Concrete Pavement Initiatives

Neal Fannin
Pavement Materials Engineer
ISSD

pennsylvania
DEPARTMENT OF TRANSPORTATION
www.dot.state.pa.us

Revisions to Sect. 516 and PTM 634 Unbonded Area of Anchor Material for Dowel Bars

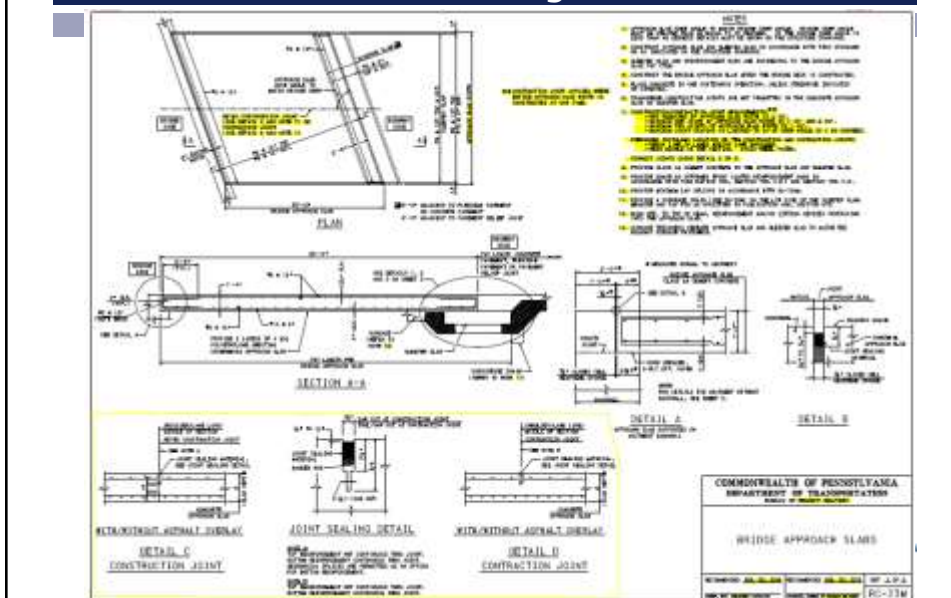
- Change updates reference specification from ASTM to AASHTO and clarifies test requirements.
- In Pub. 408 Change 6, effective April 5, 2019.
